Informal document **GRVA-12-25**
12th GRVA, 24–28 January 2022
Agenda item 8(c) and 9(b)

UN Regulations No. 13-H and 78 Stop Lamp Illumination

Seeking Clarification on the term “**Deceleration Demand**” used in documents

Release Accelerator Control: Stop Lamp Illumination

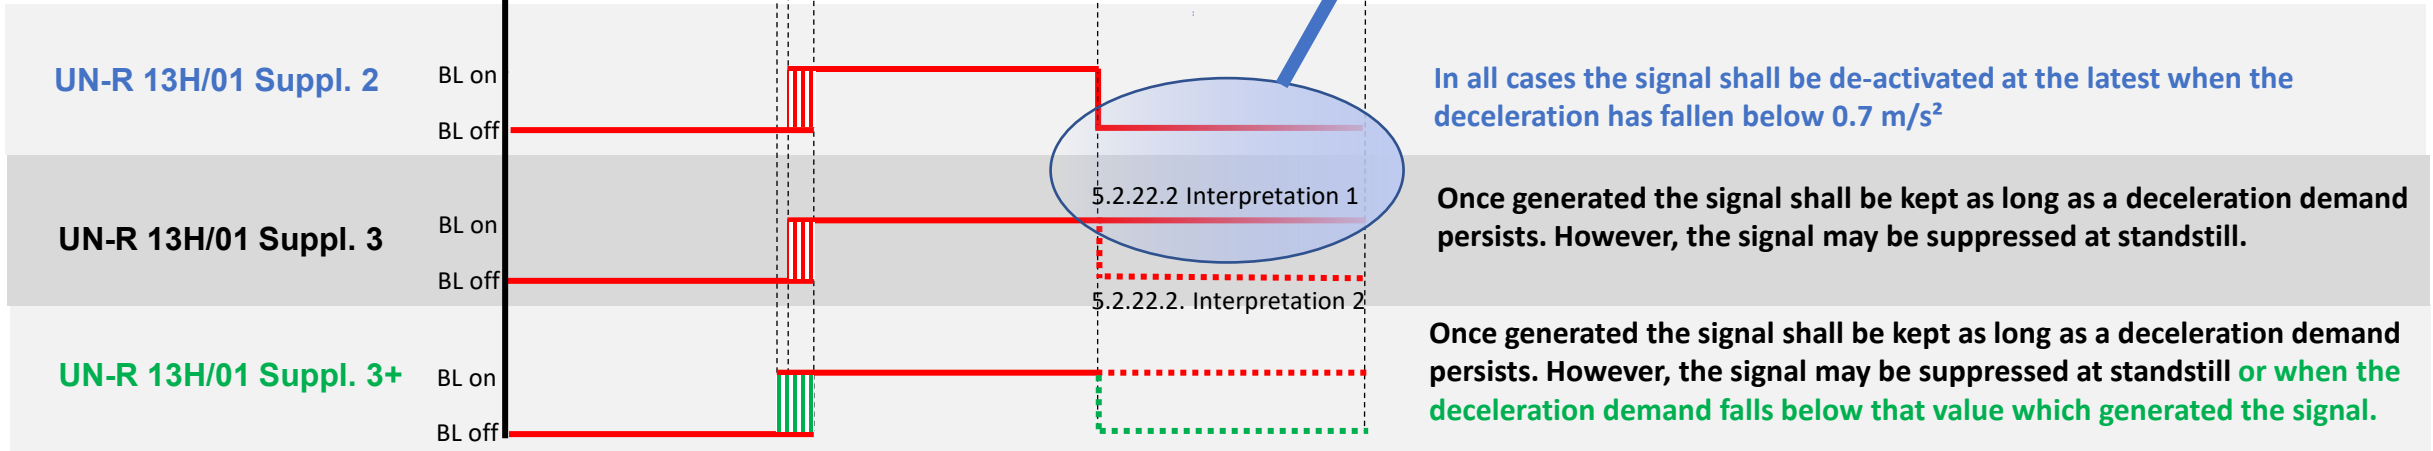
Industry currently gets different interpretations from Technical Services on the question:

When does a deceleration demand no longer persist?

... and consequently when is the signal no longer to be kept acc. to Par 5.2.22.2

With interpretation 1 of **Suppl. 3** a design change would be required as part of an extension process of an existing approval.

The **addition** would clarify the intention and align the supplement with the rules of procedure of the UNECE 58 agreement.

Industry view:

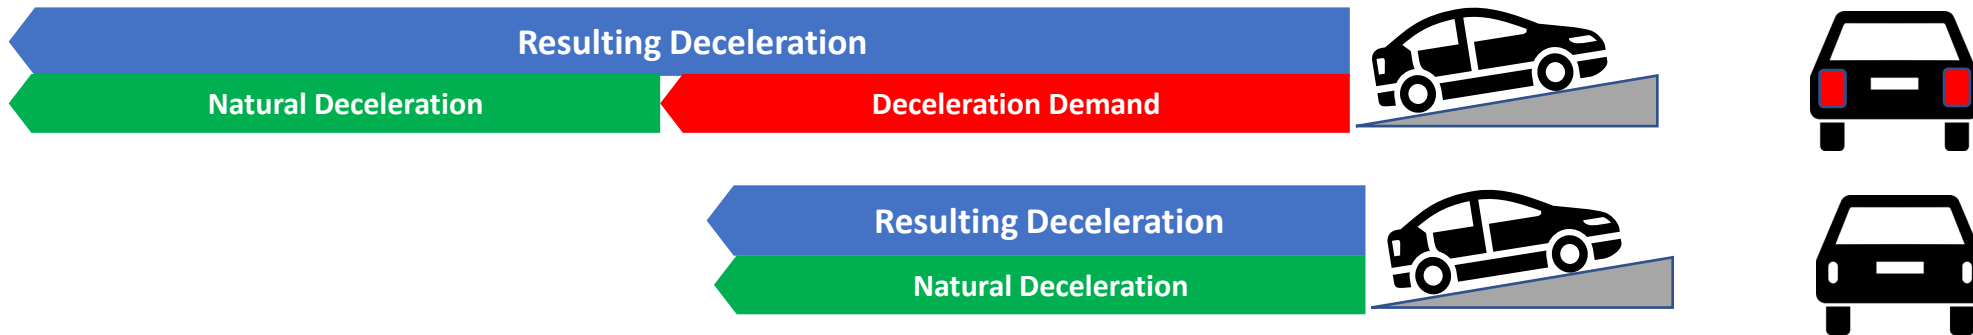
- A “Deceleration” in the sense of paragraph 5.2.22.2 is a request from an automatically commanded braking function or regenerative braking system to decelerate the vehicle => **Deceleration Demand**
- Not at all the retardation effects as described in Paragraph 5.2.22.4 are to be considered a braking demand.

This understanding matches with the Stop Lamp definition from R48:

2.5.4. "Stop lamp" means a lamp used to indicate to other road users to the rear of the vehicle that the longitudinal movement of the vehicle is intentionally retarded.

The addition in GRVA-11-39 would avoid different interpretations and align the supplement with the rules of procedure of the UNECE 58 agreement.
